**Review and Evaluation of
Russellville Solar, LLC
Siting Assessment Report
Case Number: 2021-00235**

June 9, 2022

Kentucky State Board on Electrical Generation and Transmission Siting
211 Sower Blvd.
P.O. Box 615
Frankfort, Kentucky 40602

BBC Research & Consulting
1999 Broadway, Suite 2200
Denver, Colorado 80202-9750
303.321.2547 fax 303.399.0448
www.bbcresearch.com

Figure C-1.
Preliminary Site Layout for Russellville Solar Project

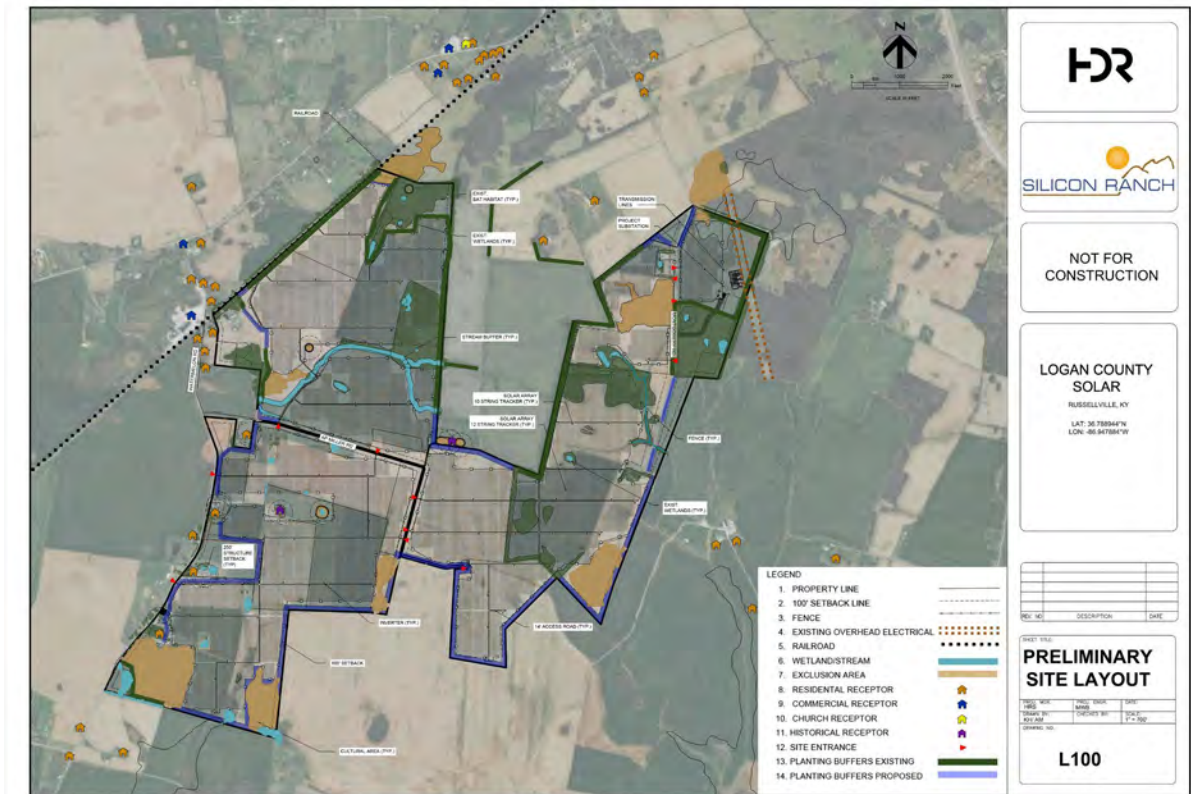
site layout, close detail of project features is viewable in full in Exhibit D of the SAR (Preliminary Site Layout), including proposed locations of boundary fencing, existing and proposed vegetative buffers, a 100-foot setback line (pertinent to the Logan County setback requirements, discussed later in this report), and solar arrays. In the Siting Board's First RFI, BBC asked Russellville Solar to provide an updated site map including all site access points.

Figure C-2.
Map of Surrounding Residential Neighborhoods, Russellville Solar Project

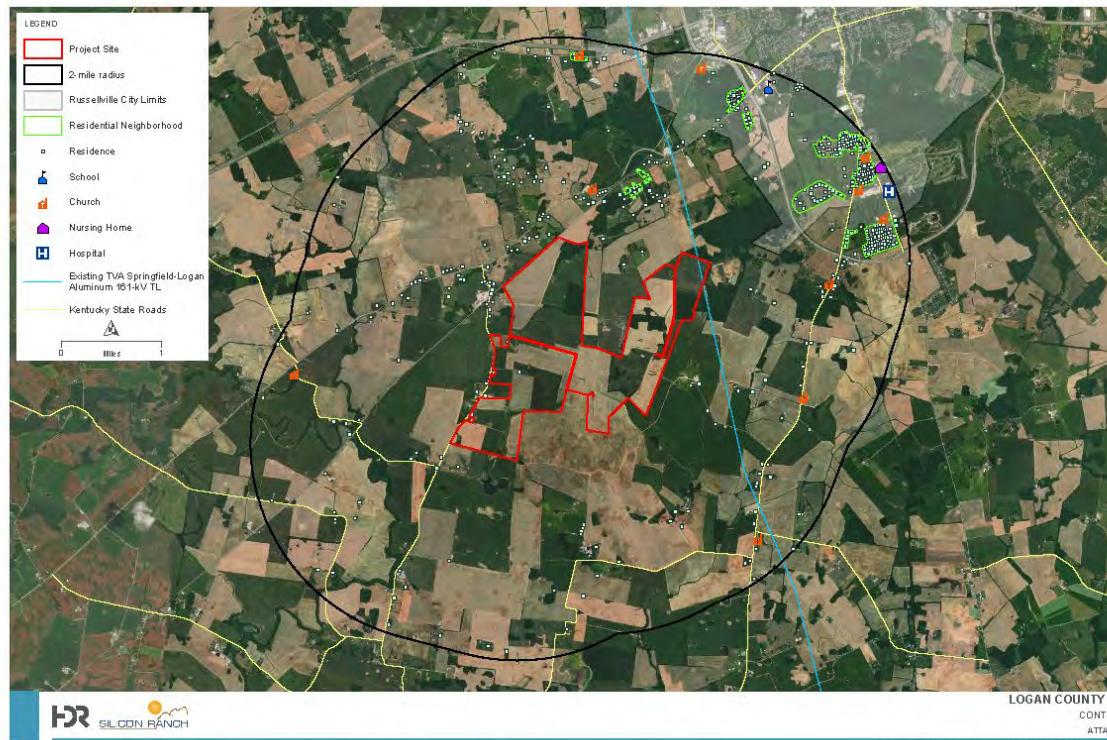
In the Siting Board’s First RFI, BBC requested that Russellville Solar provide an updated high-level map with additional features, such as varying radius measurements around the proposed project boundary. BBC also requested a count of the residential neighborhoods identified according to KRS 278.700, which states that a residential neighborhood is a populated area of five or more acres containing at least one residential structure per acre.

Figure C-4.
Preliminary Site Layout for Russellville Solar Project, Potential Site Access Points Added by BBC

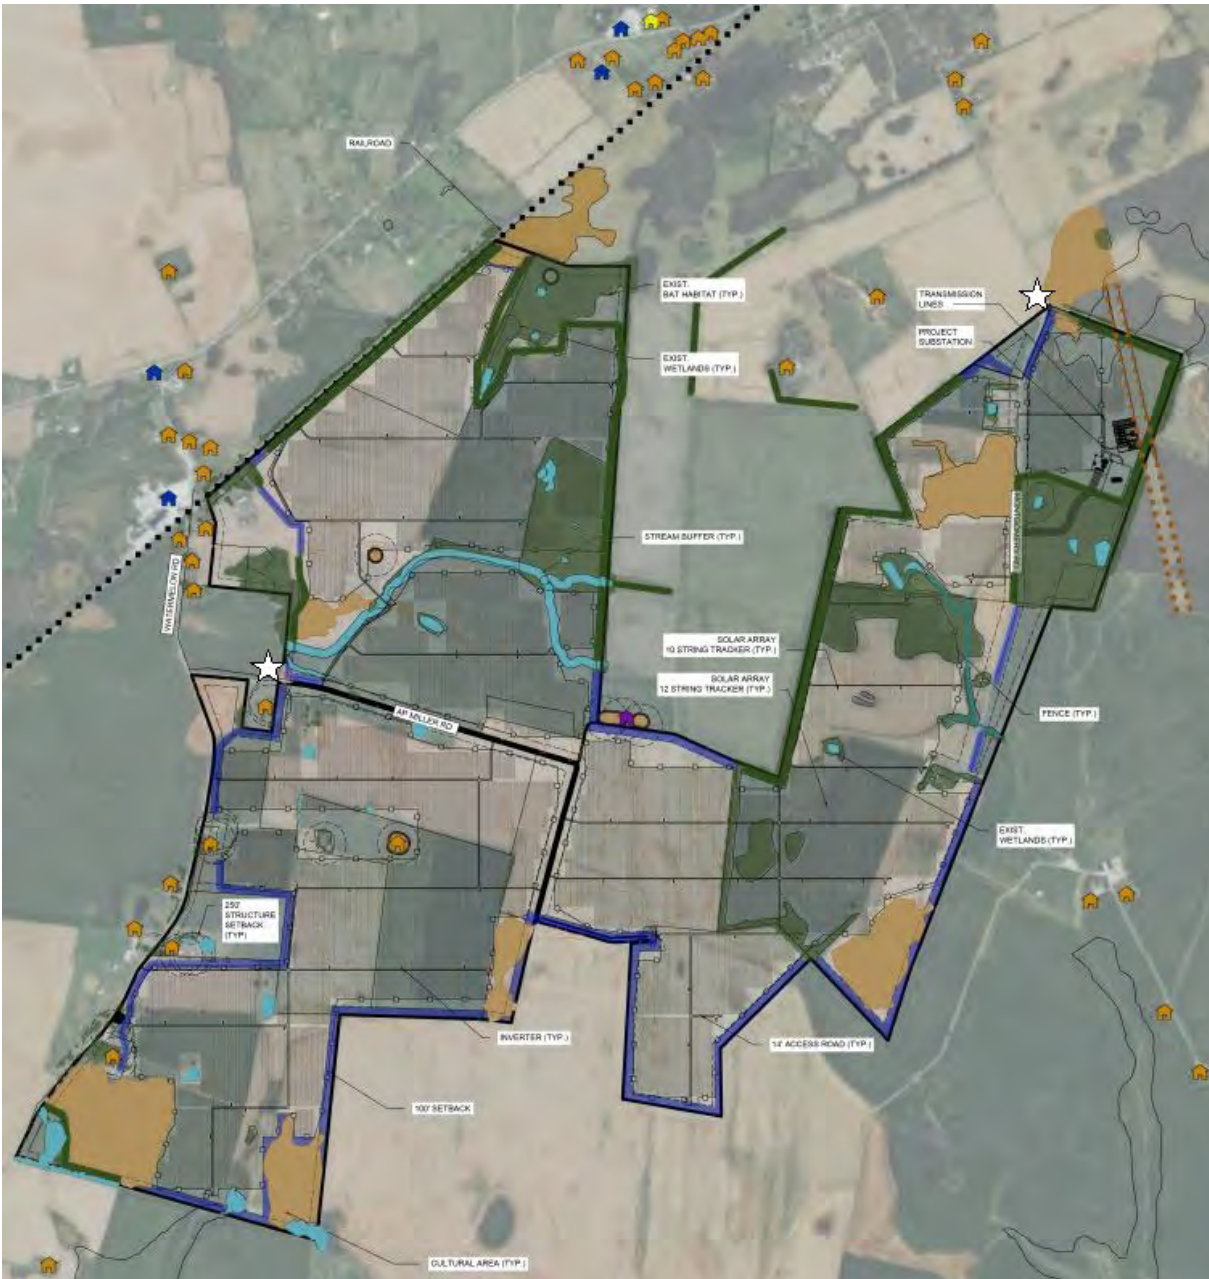
BBC has modified the applicant's preliminary site layout map to mark the presumed access points to the proposed site, based on the written description in Exhibit E. These are marked with white stars in Figure C-4. BBC requested clarification regarding access ways in the First RFI and further detail regarding access points is provided later in this section. An updated version of this figure is provided later in this section as Figure C-6.

Figure C-6.
Updated Preliminary Site Layout, Russellville Solar Project Site

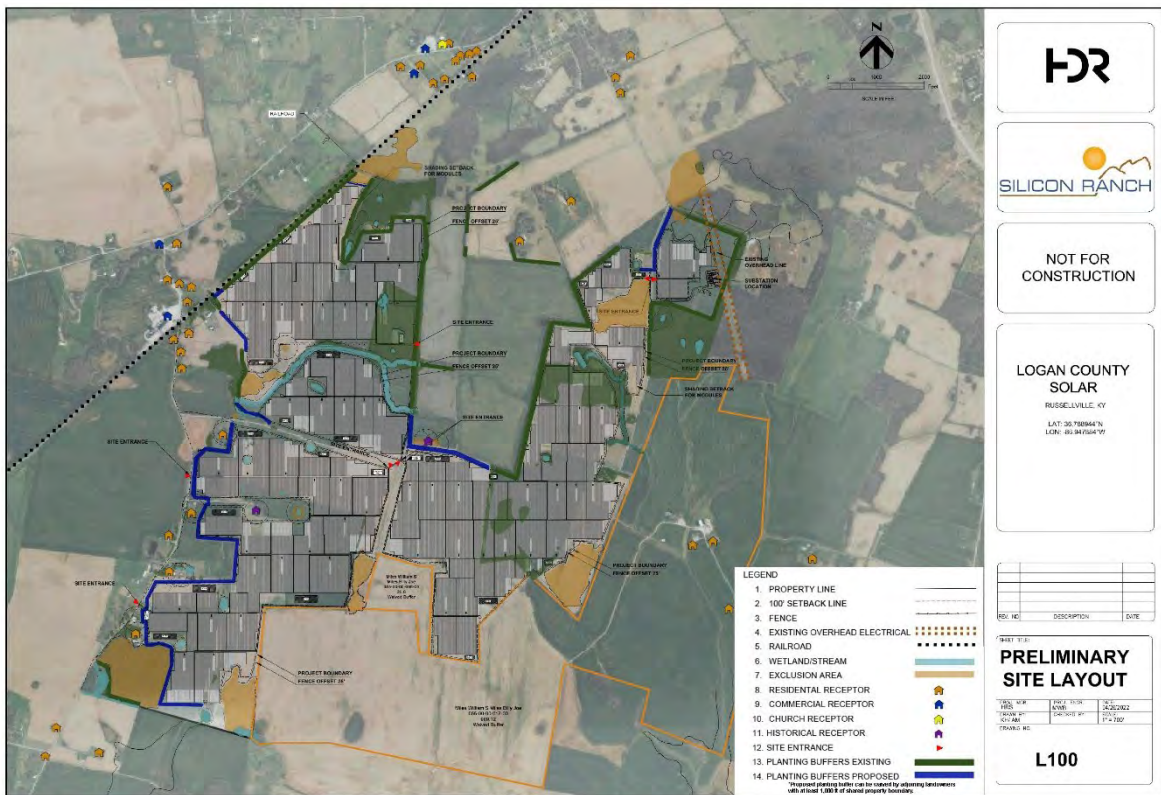
Location and use of access ways, internal roads, and railways. In response to a question from BBC in the First RFI, Russellville Solar provided an updated preliminary site layout map showing 12 potential access points. Further information provided verbally during the site visit indicated Russellville Solar expected to reduce the number of access points, and Russellville Solar provided a further refined figure showing seven access points in response to questions in the Siting Board’s Second RFI, as shown in Figure C-6.

Site access points are marked with red arrows. In total, there are seven access points shown: two along Watermelon Road, two along AP Miller Road and adjacent private road, two along Joe Montgomery Road in the proximity of the project substation and one north of Joe Montgomery Road that would provide access to the northwestern portion of the project footprint.

Figure C-16. Noise Sensitive Receptors within a Half Mile of the Russellville Solar Facility, Updated

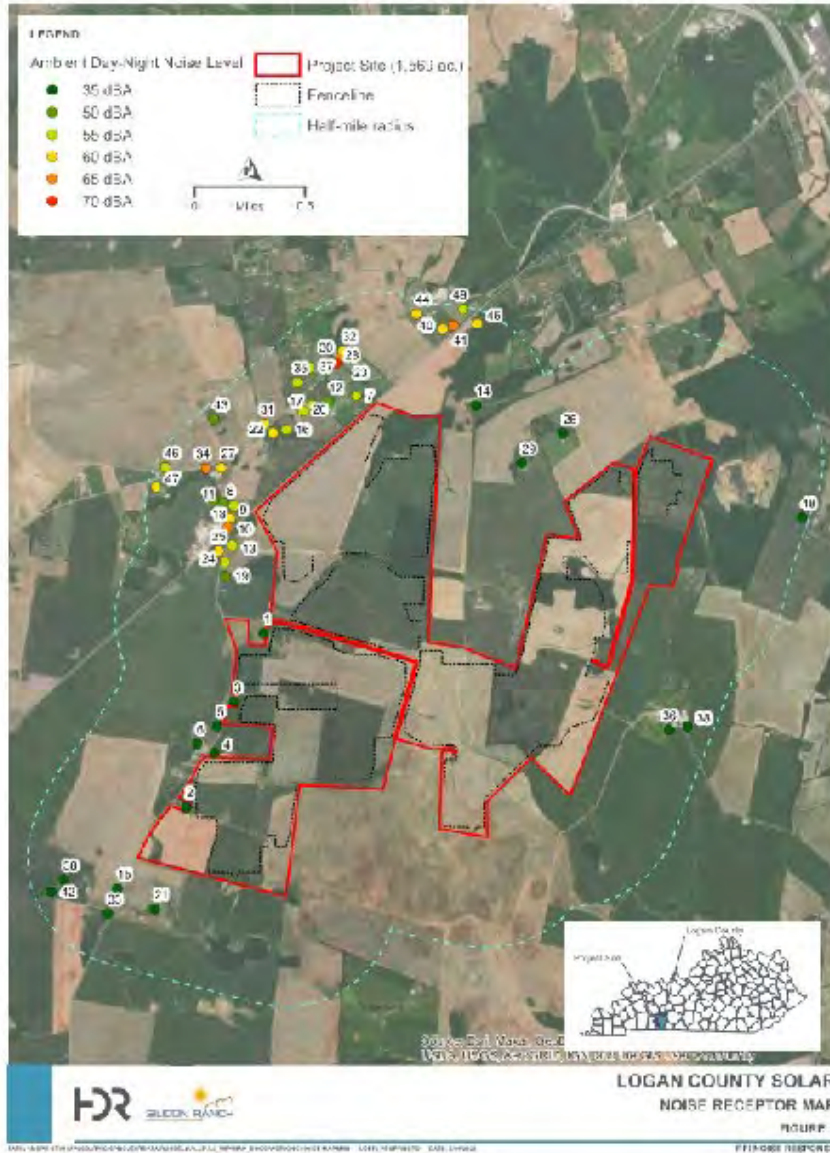
HDR updated the count of noise-sensitive receptors around the project site. The original documents stated 113 noise-sensitive receptors with a half-mile radius of the proposed project site, but this was recalculated to 49, to exclude offices, barns, and garages which are not considered noise sensitive in environmental noise analyses. To resolve some confusion regarding the numbering of nearby receptors, Russellville Solar provided a second revised map in response to the Second RFI. Figure C-16 shows the updated map of noise-sensitive receptors, which consist primarily of residences, as well as any churches, schools, or hospitals.
